# **RBWM Comments on the Regulation 14 Consultation draft of the Maidenhead Neighbourhood Plan**

**December 2024**

*Placemaking area town centre boundary in the BLP - see blue line below:*

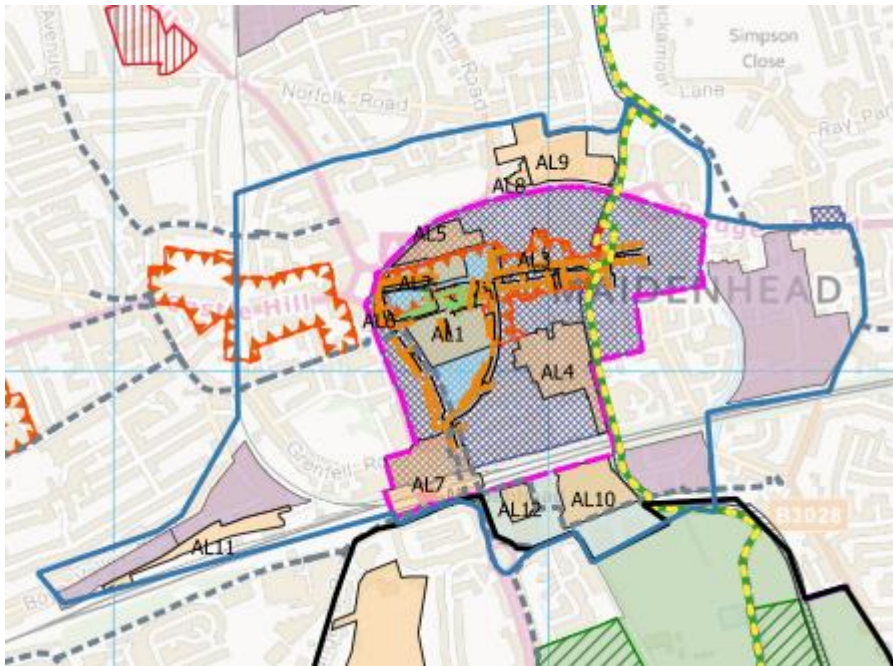
Town Centre Boundary – the town centre boundary referred to in this policy is the one shown below in Policy DE-1 – extract below.

We note this is different to the town centre boundaries shown in the BLP. There are 2 different town centre boundaries in the BLP, one relating to retail policies and the other to show the placemaking area for Maidenhead Town Centre (see below), so across the two plans there could be three different town centre boundaries.

It may be beneficial and less confusing to use one of the town centre boundaries in the BLP for policies in the Neighbourhood Plan to relate to, and we would recommend the Placemaking area boundary, having regard to the policies that specifically relate to the town centre boundary (e.g. housing mix and car parking).

**MNF 1.6**
